VALUE ENGINEERING STUDY

Project # IM000-0285-01(346) PI No. 713210-

I-75 NB C-D System from Forest Parkway to I-285
Clayton County, Georgia

25 August 2011

PROPOSAL NUMBER: R-6.0

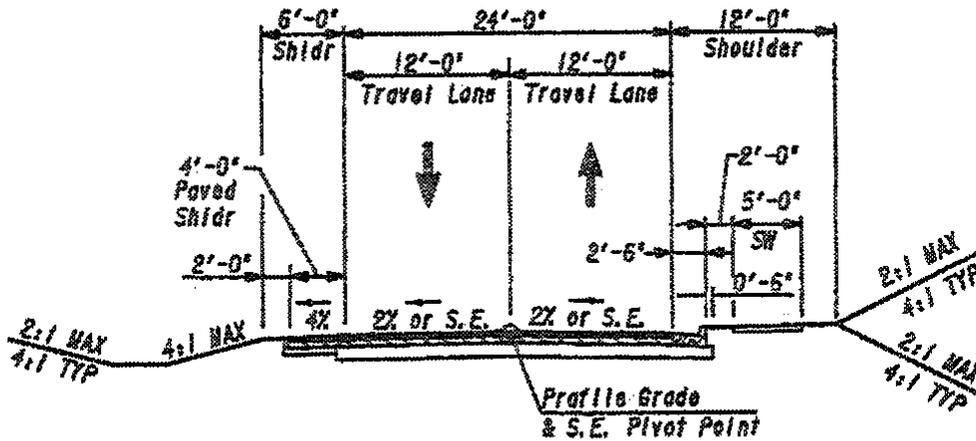
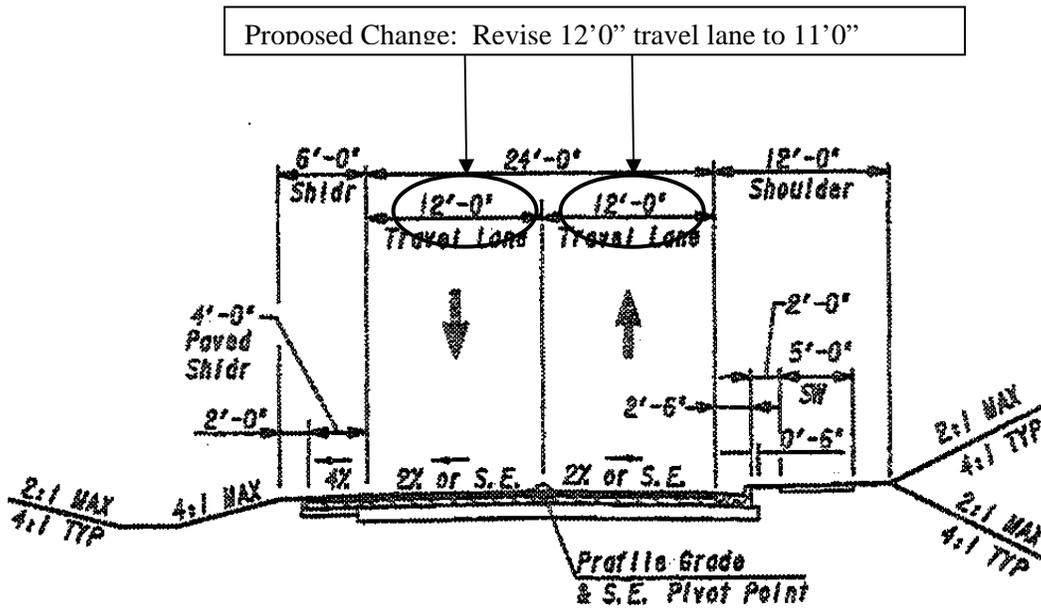
PROPOSED CHANGE: It is proposed to reduce the width of both travel lanes on the frontage road from 12' to 11'.

JUSTIFICATION: The frontage road is designed as a 35 mph local roadway and GDOT policy allows 11' lanes as indicated on Table 6.4 of the Design Policy Manual. This change also meets AASHTO guidelines for lane widths.

PROPOSAL NUMBER: R-8.0

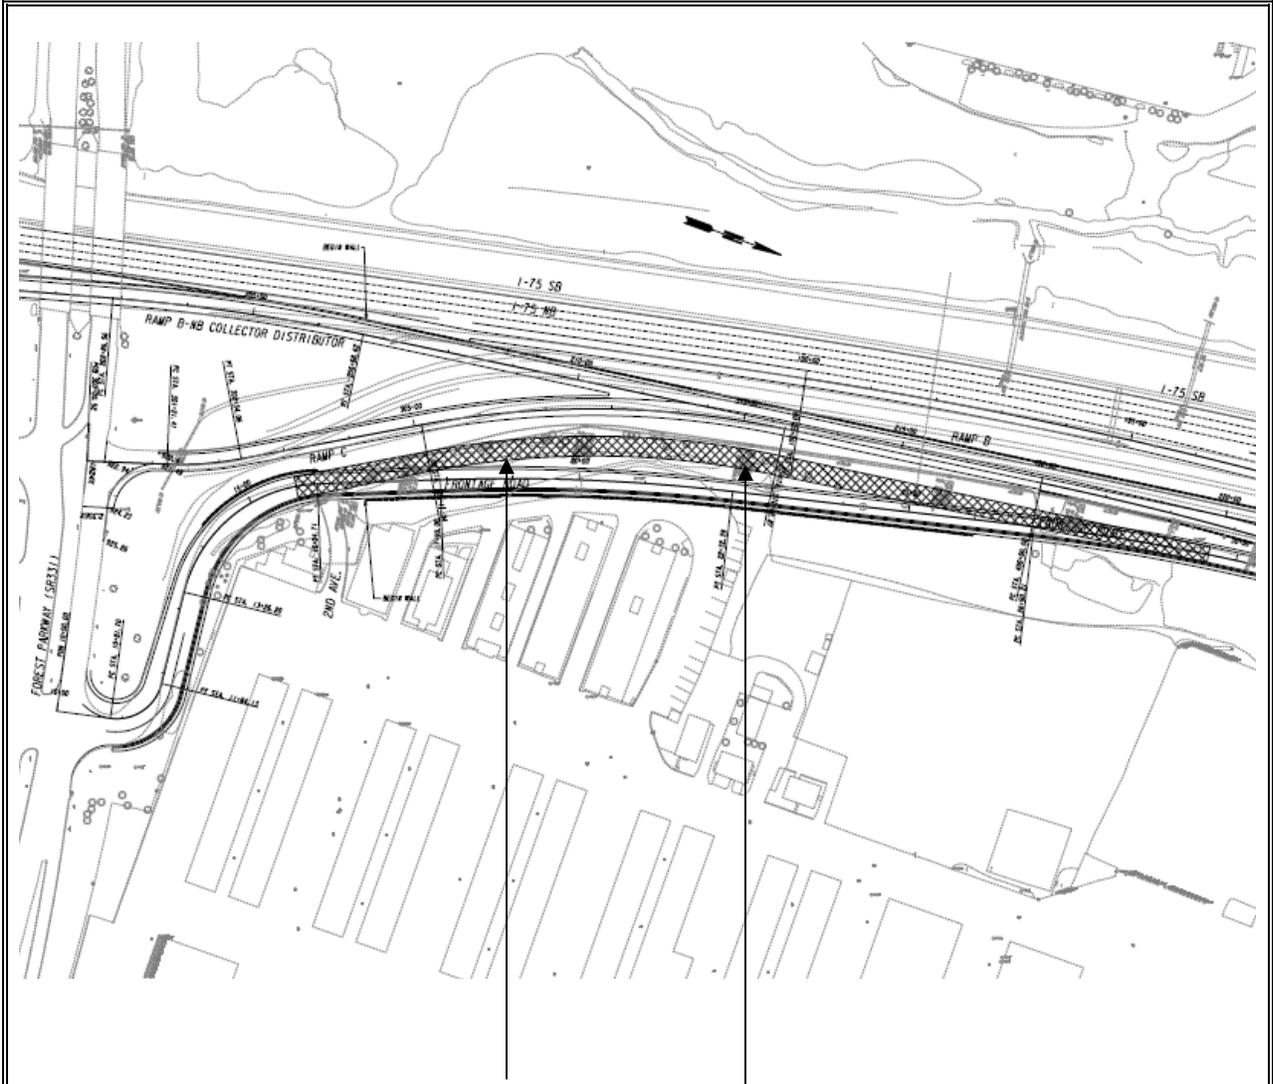
PROPOSED CHANGE: It is proposed to move the Frontage Road adjacent to Ramp 'C' between STA 16+00 and STA 31+00.

Proposed Change: Move Frontage Road toward I-75/Ramp "C"

Current Design: Loop Ramp 'A' at 30 MPH design speed and 205' radius; Ramp 'F' requires reconstruction

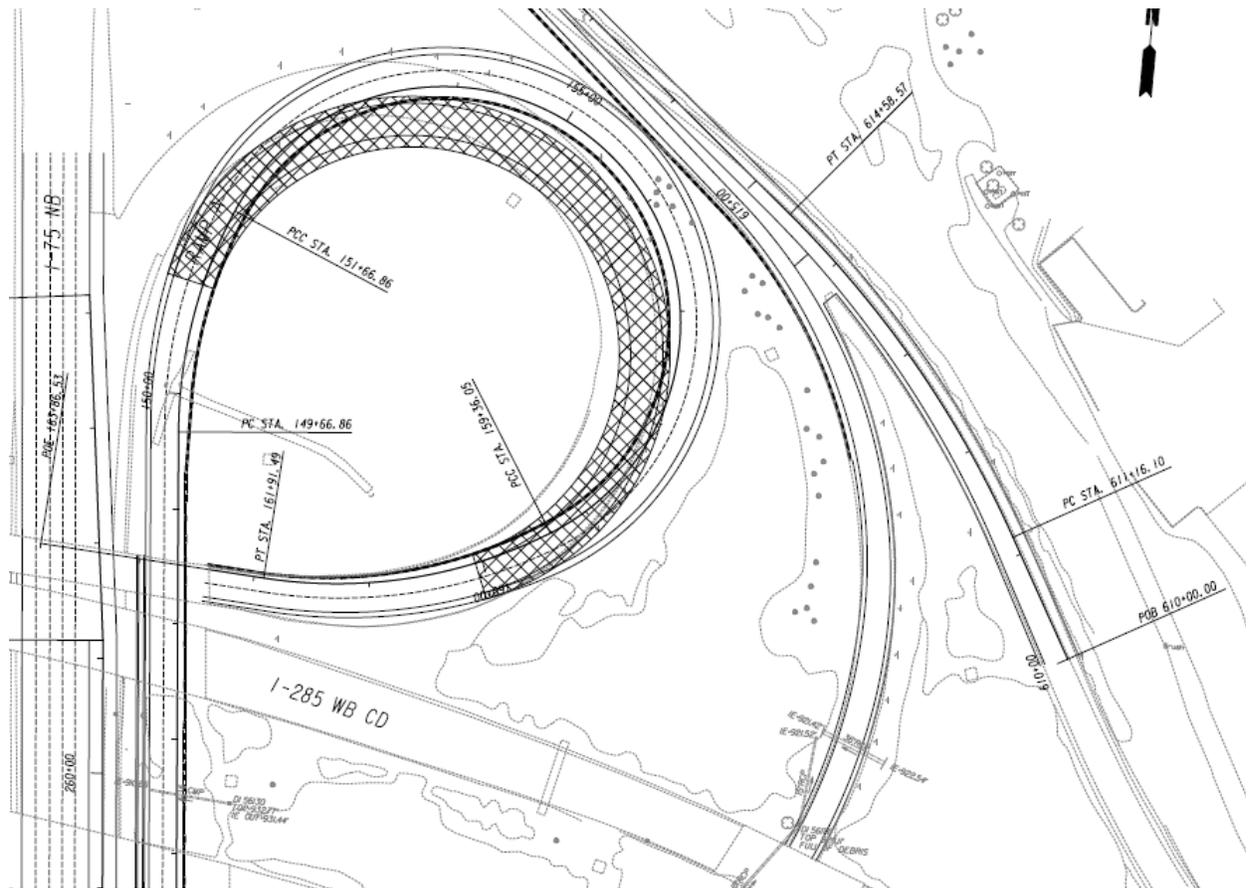
PROPOSED CHANGE: It is proposed to use a design speed of 25 mph, a 175 foot radius and a maximum super-elevation rate of 10% on Ramp 'A'. This would allow Loop Ramp 'A' to be reconstructed without requiring the reconstruction of Ramp 'F'.

Proposed Change: Loop Ramp 'A' at 25 MPH design speed and 175' radius; avoids reconstruction of Ramp 'F'

PROPOSAL NUMBER: R-10.0

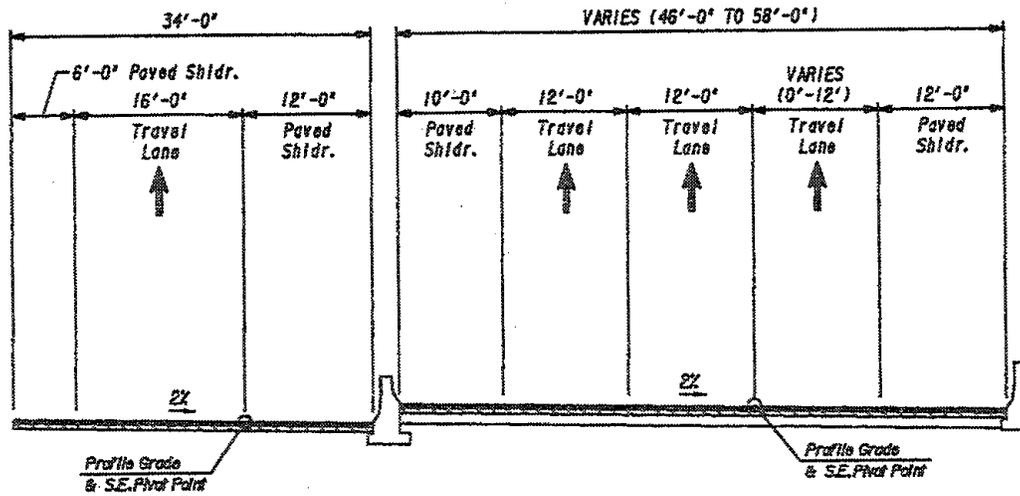
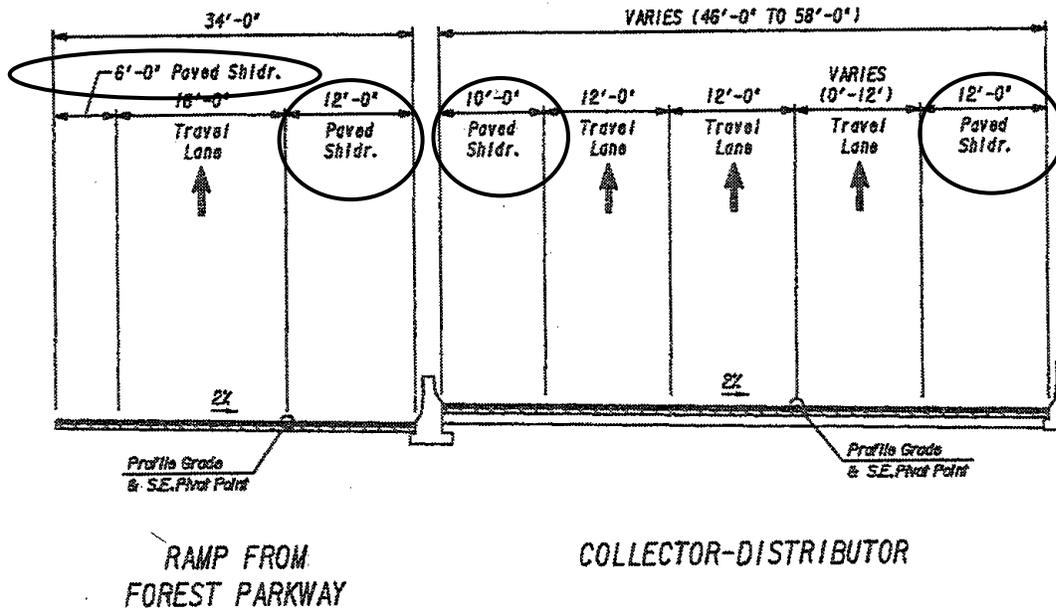
ORIGINAL DESIGN: The original typical sections show 6 foot inside and 12 foot outside shoulders for all one-lane and two-lane ramps and C-Ds; and 10 foot inside and 12 foot outside shoulders for all three-lane C-Ds.

PROPOSED CHANGE: It is proposed to provide 4 foot inside and 10 foot outside shoulders for all one-lane and two-lane ramps and C-Ds; and three-lane C-Ds.

Proposed Change: Reduce inside shoulders to 4' wide paved and outside shoulders to 10 foot paved

PROPOSAL NUMBER: R-11.0

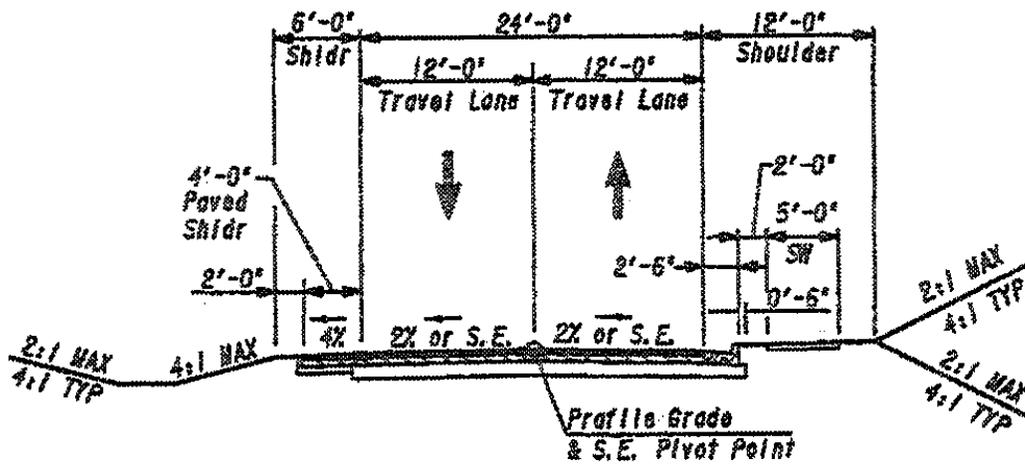
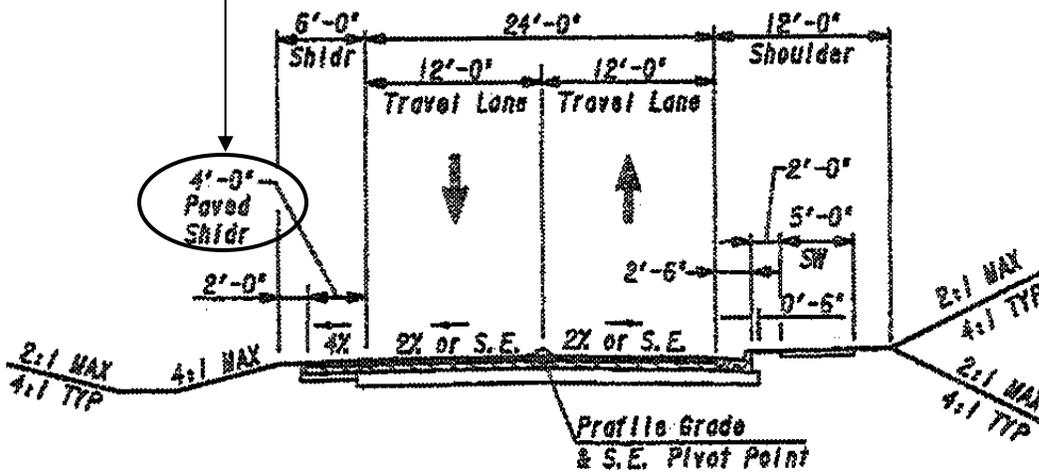
ORIGINAL DESIGN: The frontage road on the east side of I-75 is designed with curb and gutter on the east side of the road and a paved shoulder on the west side. The design includes a 4' wide paved portion (although other typical sections show 6' and 10' paved portions).

PROPOSED CHANGE: It is proposed to reduce the width of the paved shoulder on the west side of the frontage road to 2'.

Proposed Change: Reduce 4'0" paved shoulder to 2'0"

PROPOSAL NUMBER: R-12.0

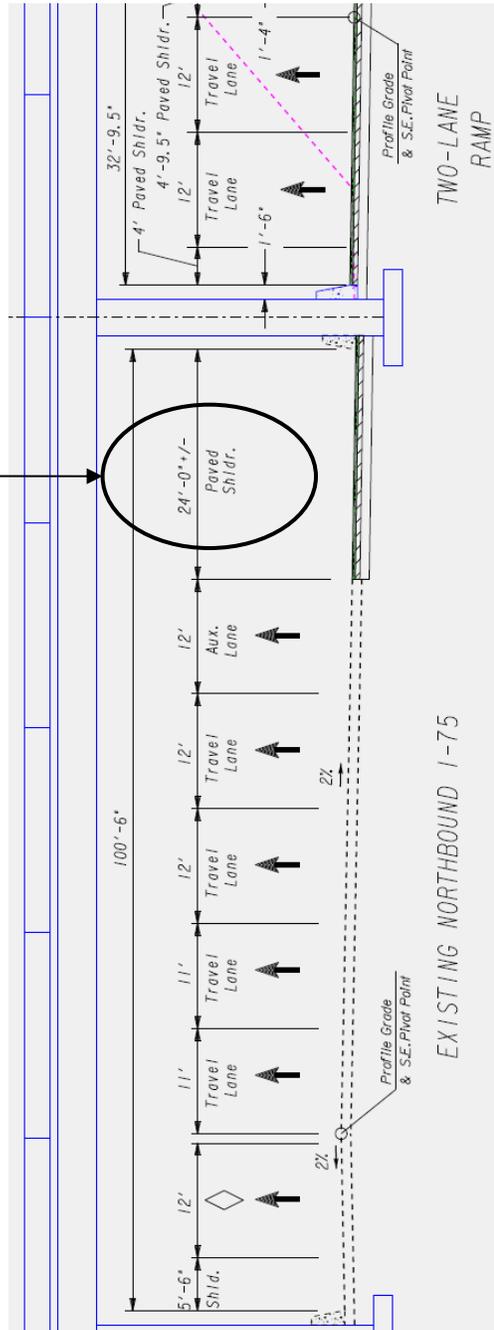
PROPOSED CHANGE: It is proposed to reduce the width of the paved shoulder along I-75 from 24' at the I-285 bridges to 12'. Gravel would be placed in the remaining 12' outer strip.

JUSTIFICATION: The 12-foot wide paved shoulder meets AASHTO requirements for the interstate, results in a reduction in impervious surfaces and would provide a cost savings to the project.

Proposed Change: Reduce from 24' to 12' paved, outer 12' to be gravel

PROPOSAL NUMBER: R-15.0

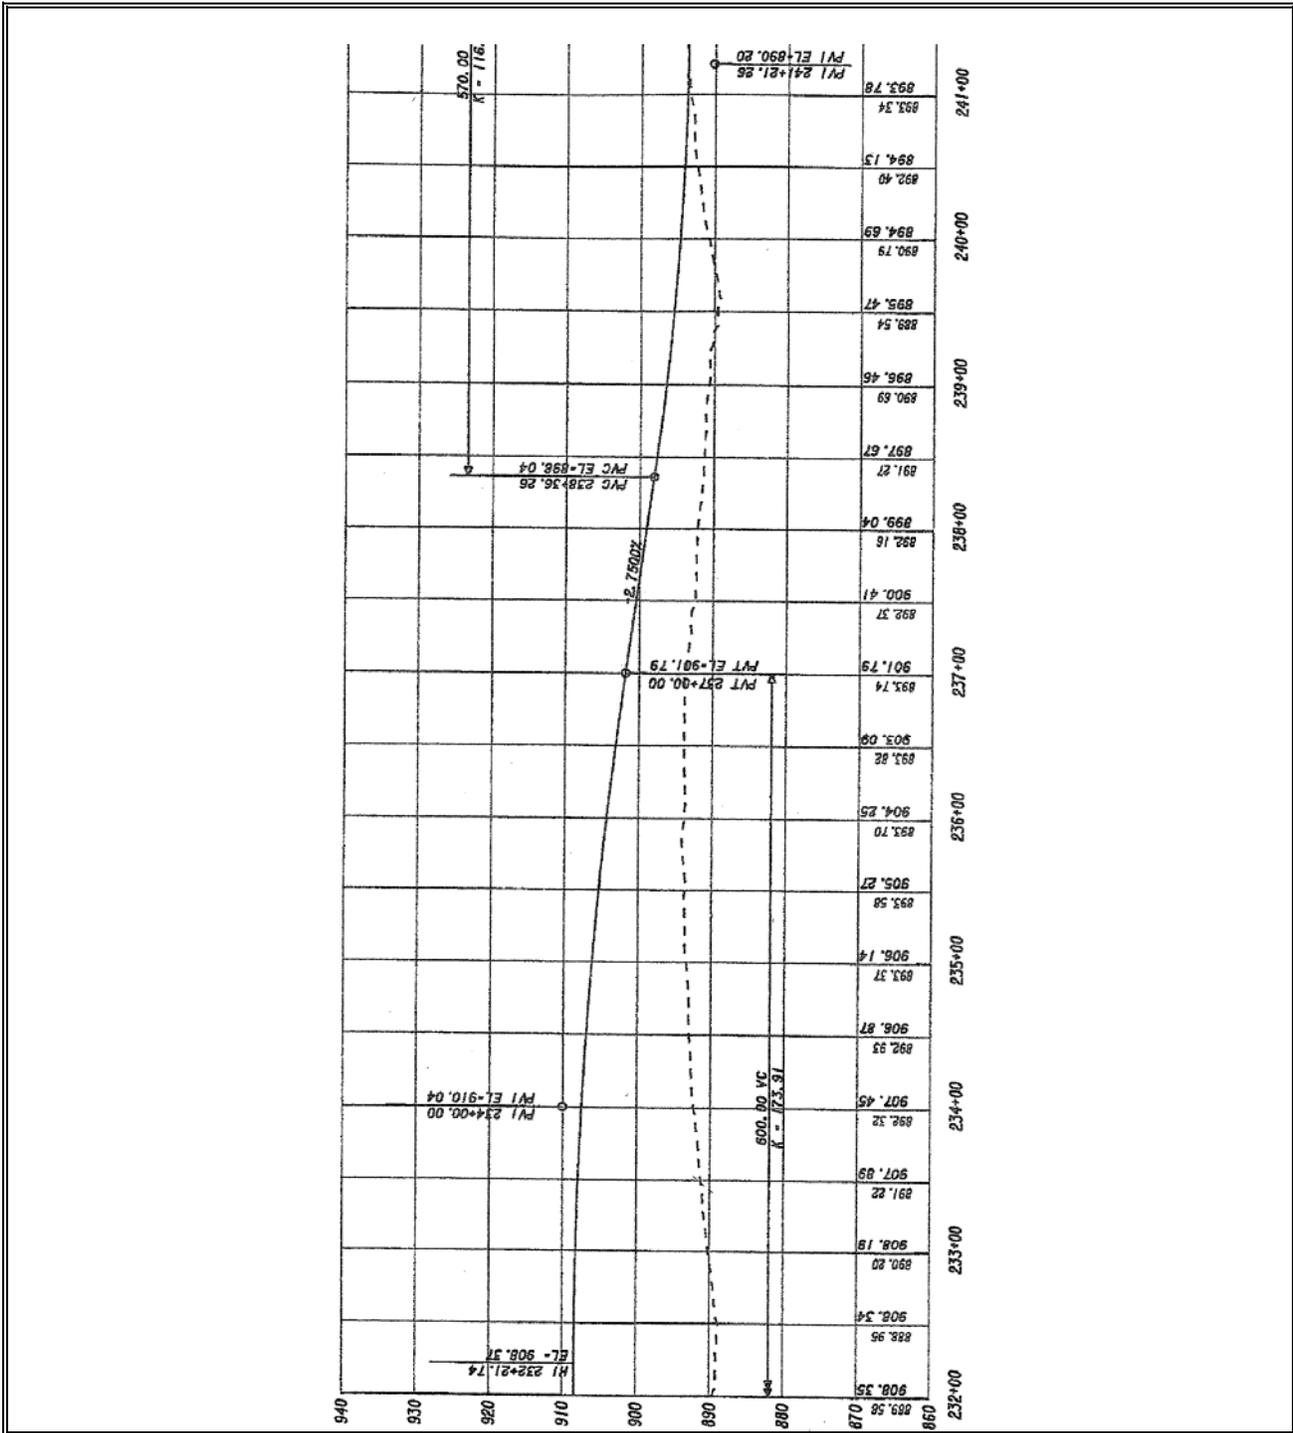
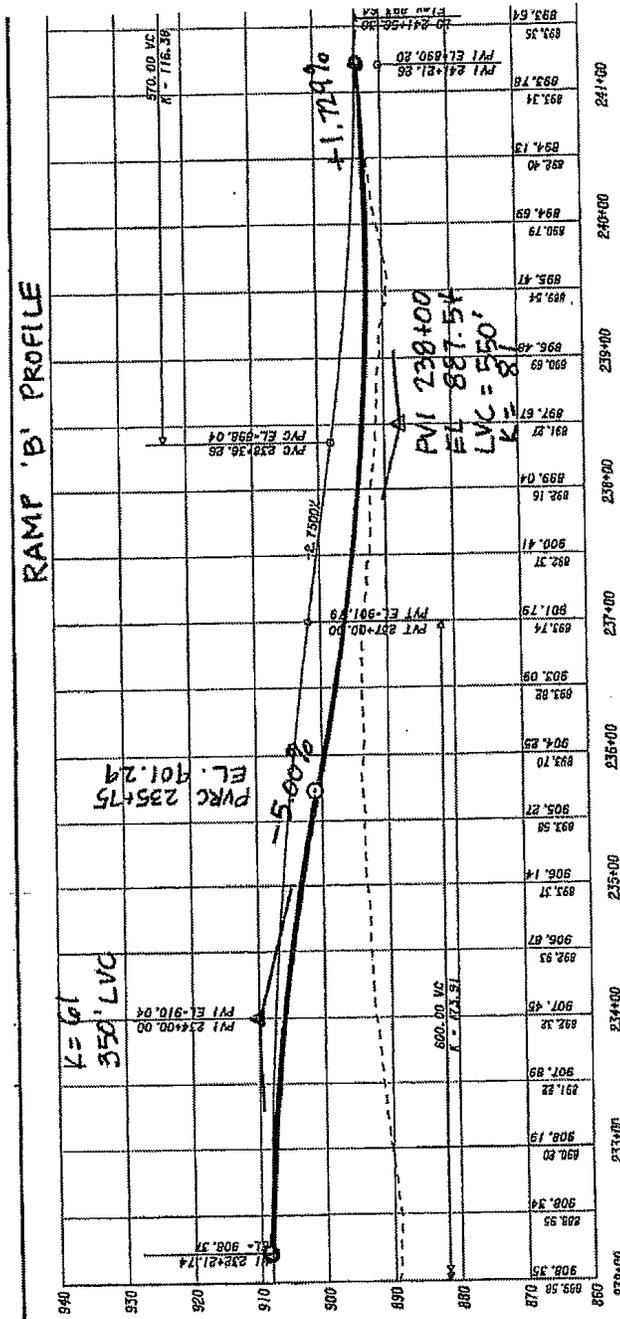
PROPOSED CHANGE: It is proposed to increase the profile grade of Ramp 'B' from the PVI at STA 234+00 to 5% and move the ramp nose to approximately STA 241+00 and reduce the height of the associated walls. (PVI STA 234+00, Elev. = 910.04, LVC = 350'; PVI STA 238+00, Elev. 887.54, LVC = 550'; PVI STA 246+05.32, Elev. 900.60, LVC = 300')
